CONTRACT CHANGE ORDER NO. ____
SHEET ___ OF ___

MARK	DATE	DESCRIPTIONS	BY	CH'D	CCO#
2	04/05/12	SUSPENSION SYSTEM SHIMS	GB	MN	240
1	04/16/07	CABLE SYSTEM	GB	DT	37

SAN FRANCISCO OAKLAND BAY BRIDGE
EAST SPAN SEISMIC SAFETY PROJECT
SELF-ANCHORED SUSPENSION BRIDGE
(SUPERSTRUCTURE & TOWER)

SUSPENDER BRACKET DETAILS NO. 2

SUSPENDER BRACKET DETAILS NO. 3

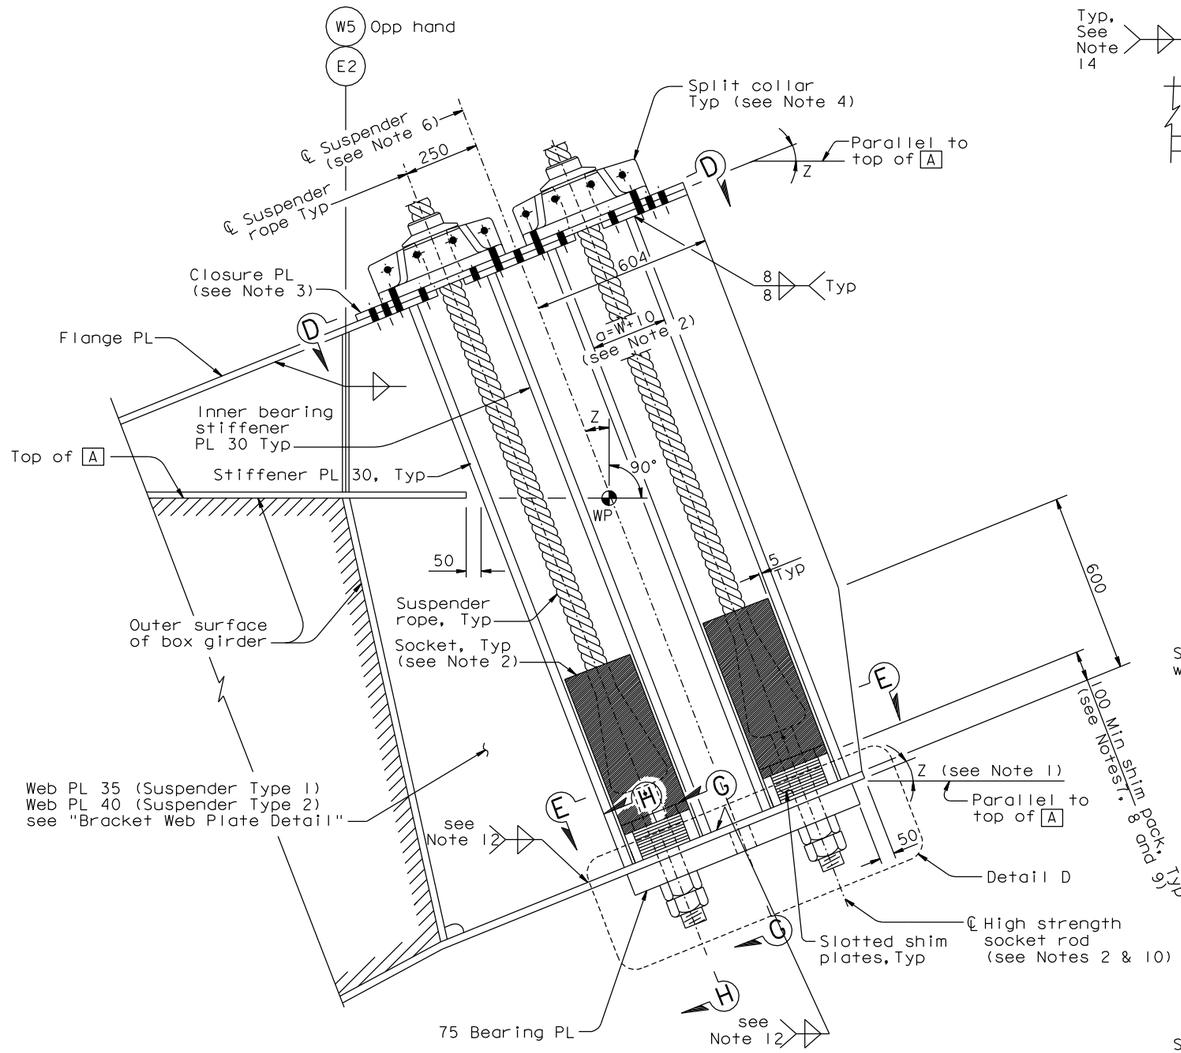
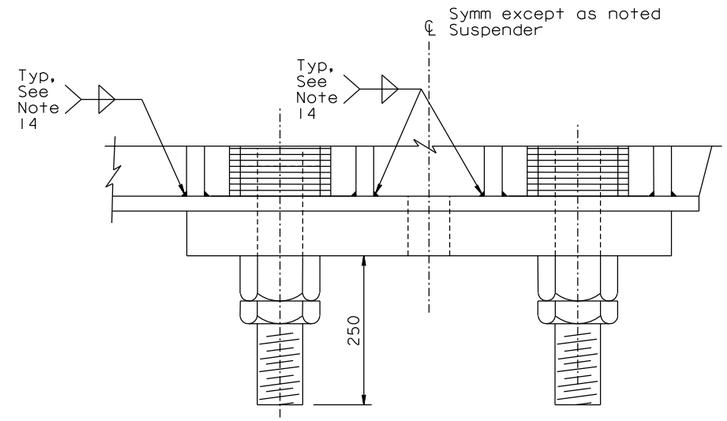
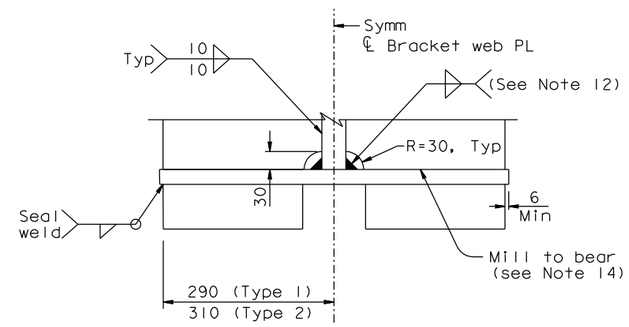
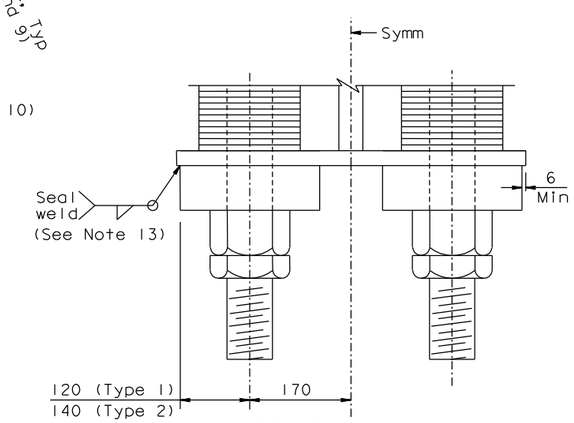
MARK	DATE	DESCRIPTIONS	BY	CH'D	CCO#
2	04/05/12	SUSPENSION SYSTEM SHIMS	GB	MN	240
1	04/16/07	CABLE SYSTEM	GB	DT	37

6. Suspender ℄ varies with bracket location. Cutouts and bolts in flange PL shall be placed with respect to suspender ℄.
7. The Contractor shall provide the specified shim pack thickness for erection adjustment as directed by the Engineer, and to provide future tension adjustment for a LRT. The Contractor may add additional shims as part of his fabrication methods, subject to approval by the Engineer.

8. NOTE DELETED. △2
9. For shim stack heights, see "Suspender Bracket Details No. 10" sheet.
10. The diameter of holes in bearing plate for socket rods shall be 4 mm greater than the rod diameter.

SLOTTED SHIM DETAIL
1:5

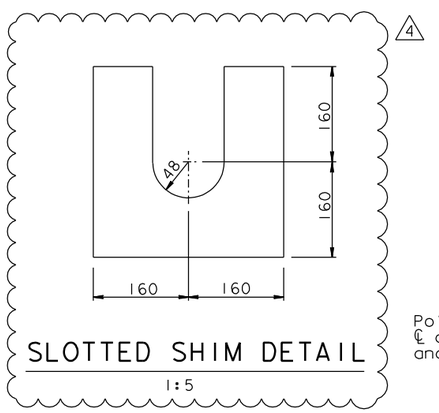
MARK	DATE	DESCRIPTIONS	BY	CH'D	CCO#
4	04/05/12	SUSPENSION SYSTEM SHIMS	GB	MN	240
3	02/20/09	SUSPENDER BRACKETS	GB	DT	104
2	08/15/08	CABLE ELECTRICAL	GB	DT	72
1	04/16/07	CABLE SYSTEM	GB	DT	37

1. Threaded rod may be used for erection. After installation of suspender socket, ends shall be sealed with 90 Dia A307 bolts.
2. For details not shown, see "Suspender Bracket Details No.1" through "Suspender Bracket Details No.3" sheets.
3. For split collar details, see "Suspender Bracket Details No.5" sheet.
4. The Contractor shall consider variation in roadway grade in his details.
5. For cable band details, see "Cable Band Details" and "Cable Handrope Details" sheets.
6. For suspender brackets at PP 108 and PP 110, see "Suspender Bracket Details No.8" and "Suspender Bracket Details No.9" sheets.
7. For shim stack heights, see "Suspender Bracket Details No.10" sheet. 4

SUSPENDER BRACKET DETAILS NO. 8

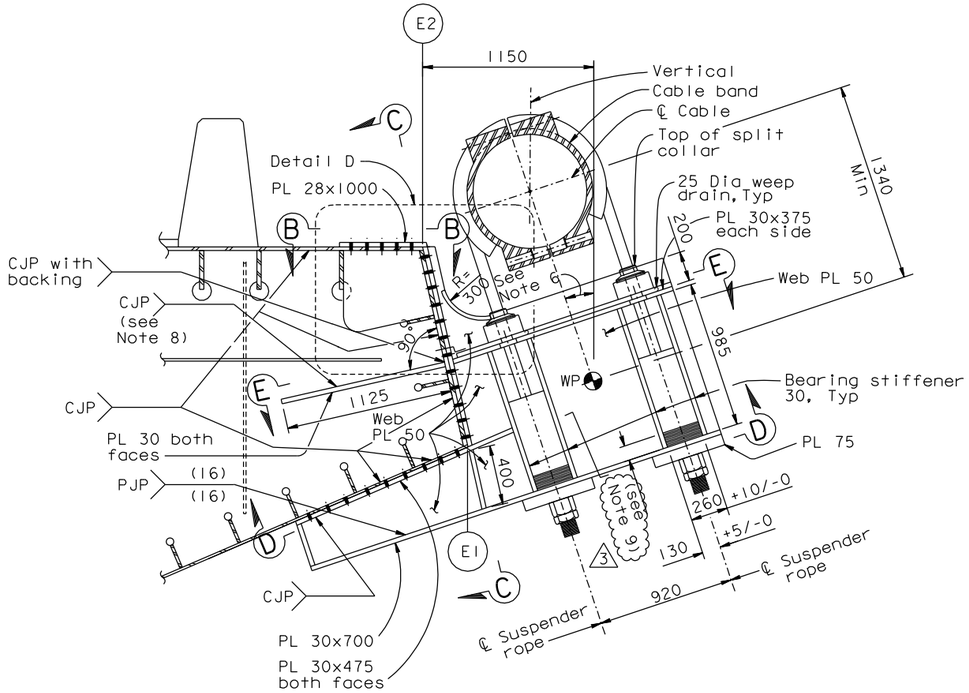
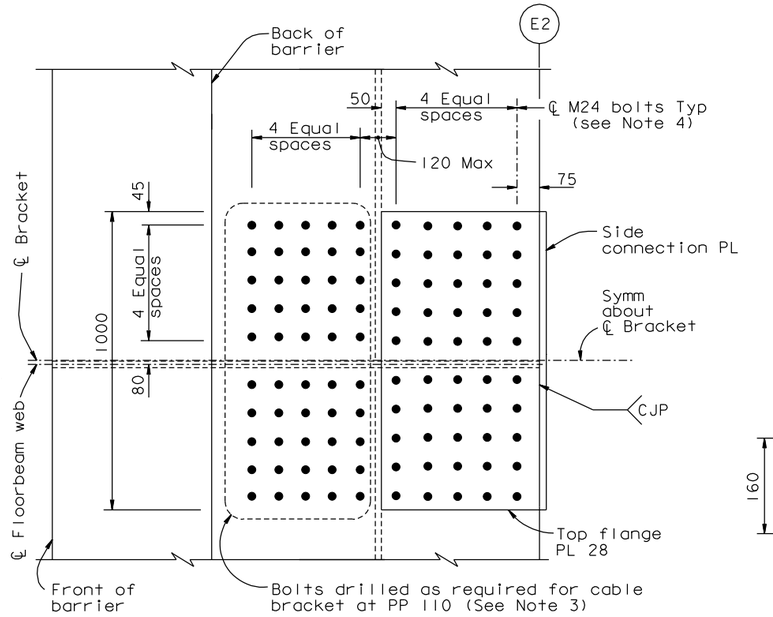
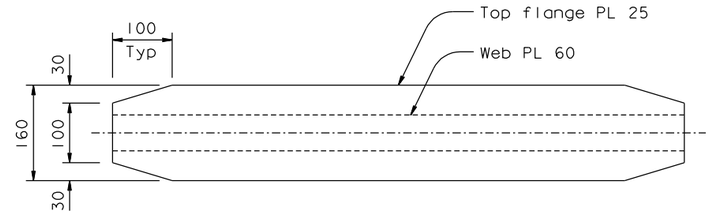
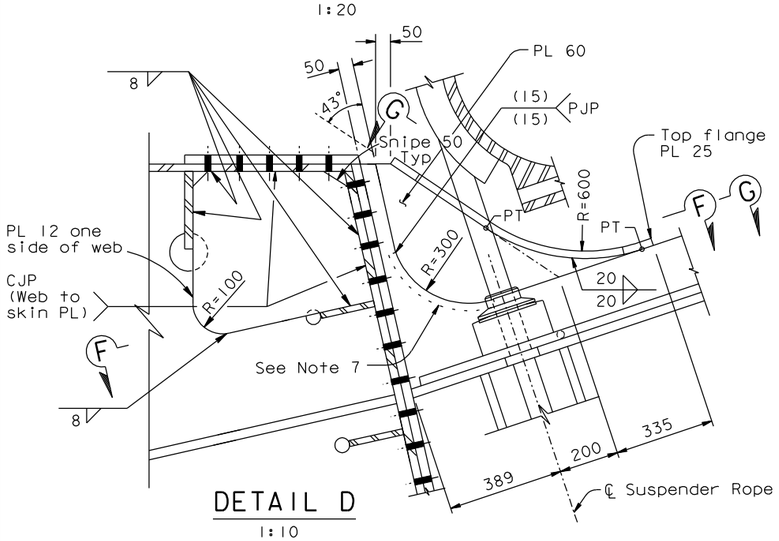
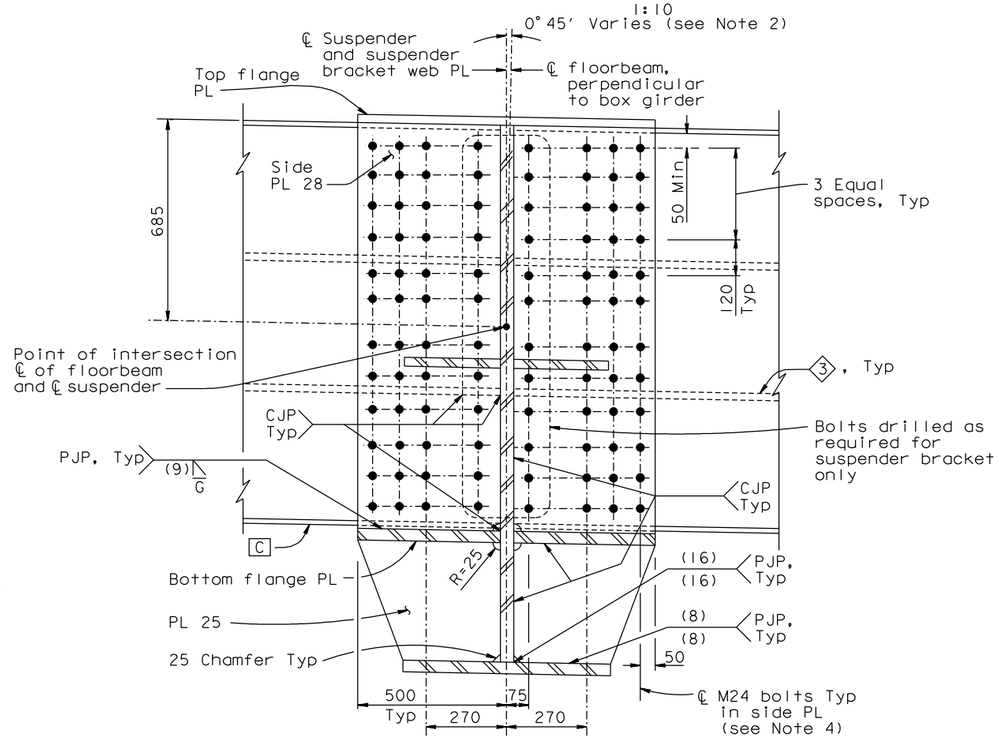
MARK	DATE	DESCRIPTIONS	BY	CH'D	CCO#
3	04/05/12	SUSPENSION SYSTEM SHIMS	GB	MN	240
2	01/05/12	FIELD MODIFICATION OF SUSPENDER BRACKETS	GB	MN	230
1	12/31/09	SUSPENDER BRACKETS	GB	MN	104
0	02/20/09	SUSPENDER BRACKETS	GB	MN	104

1. For details not shown, see "Suspender Bracket Details No.1" through "Suspender Bracket Details No.3" sheets.
2. The Contractor shall consider variation in roadway grade in his details.
3. The Contractor shall provide shop drawings for two suspender brackets at PP 110 ("E" line and "W" line). The Contractor shall fabricate and install a suspender bracket at PP 110 ("E" line and "W" line).
4. Bolt spacings shall match cable bracket details, see "Cable Bracket Details" sheets.
5. For View D-D, Section E-E and F-F, see "Suspender Bracket Details No. 9" sheet.
6. All suspender bracket components shall be fabricated to fit the computed cable profile.
7. Remove curve PL 20x50 from both sides and grind flush.
8. At the Contractor's option, CJP with backing may be used, subject to review and approval of the engineer.
9. For shim stack heights, see "Suspender Bracket Details No.10" sheet.

WEST DEVIATION SADDLE DETAILS NO.6

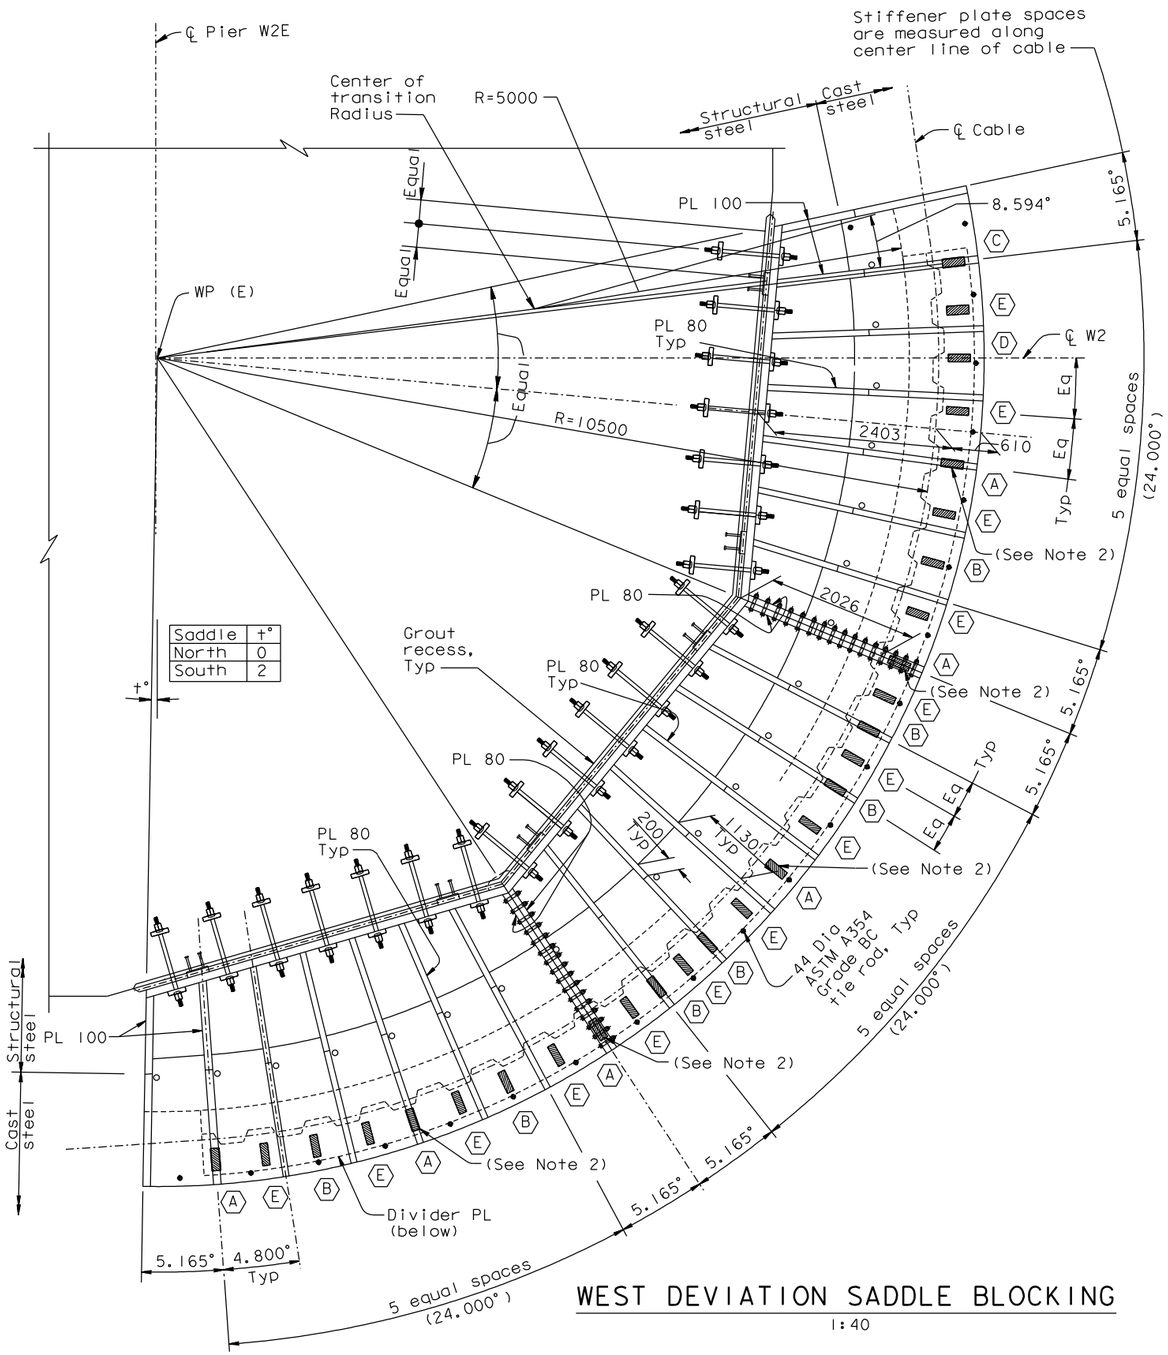
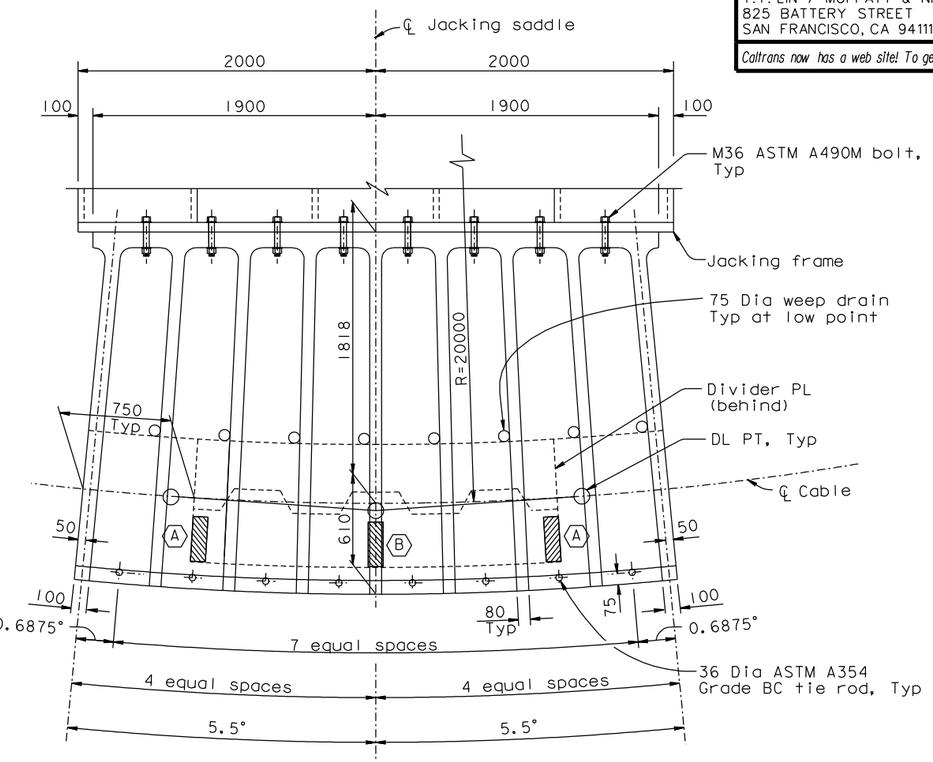
MARK	DATE	DESCRIPTIONS	BY	CH'D	CCO#
0	05/07/12	SADDLE BLOCKING	GB	MN	240

1. For blocking types and details, see "West Deviation Saddle Details No.7" sheet.
2. Blocking at these locations shall straddle the as-built divider plate radial joint.

WEST DEVIATION SADDLE DETAILS NO. 7

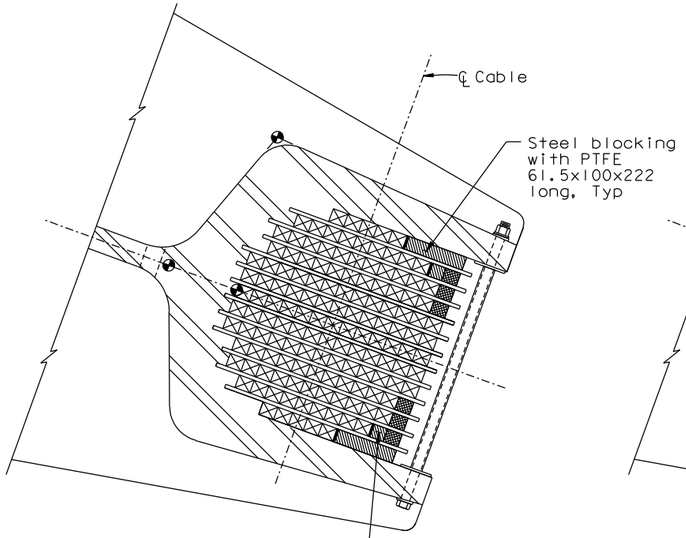
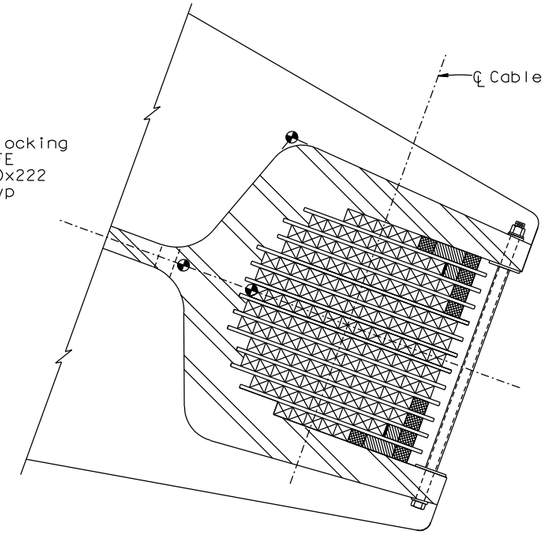
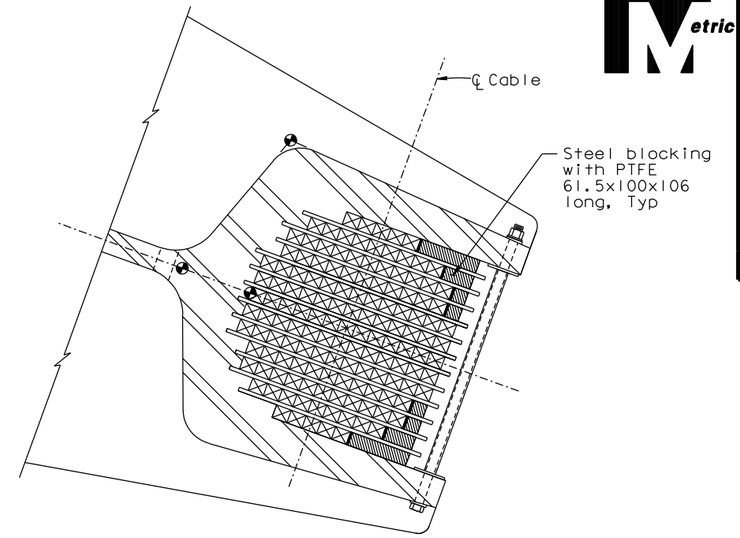
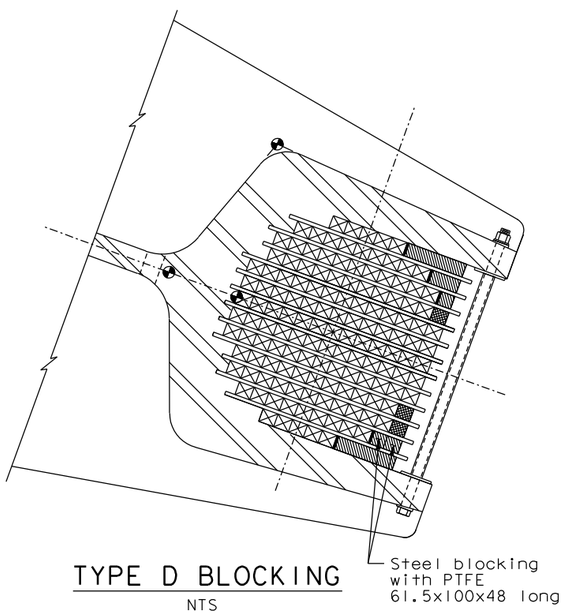
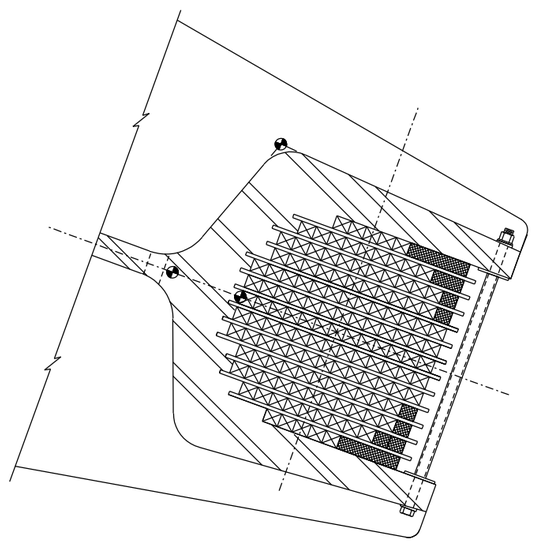
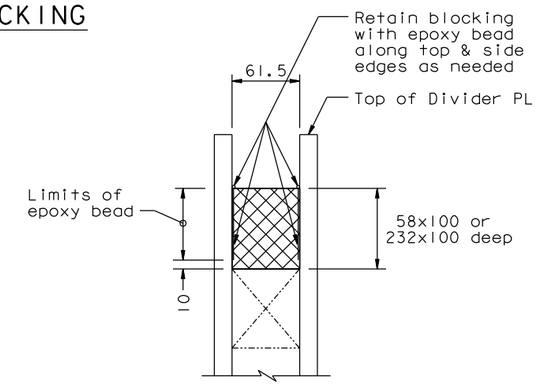
MARK	DATE	DESCRIPTIONS	BY	CH'D	CCO#
0	05/07/12	SADDLE BLOCKING	GB	MN	240

1. Steel blocking fabricated for Tower saddle shall be used for West deviation and jacking saddles.
2. At the Contractor's option, hardwood shims and blocking may be used in lieu of UHMWP.
3. The completed blocking at each location is fabricated to fit tightly. Should tight fit not be achieved, the Contractor shall inform the Engineer for evaluation.
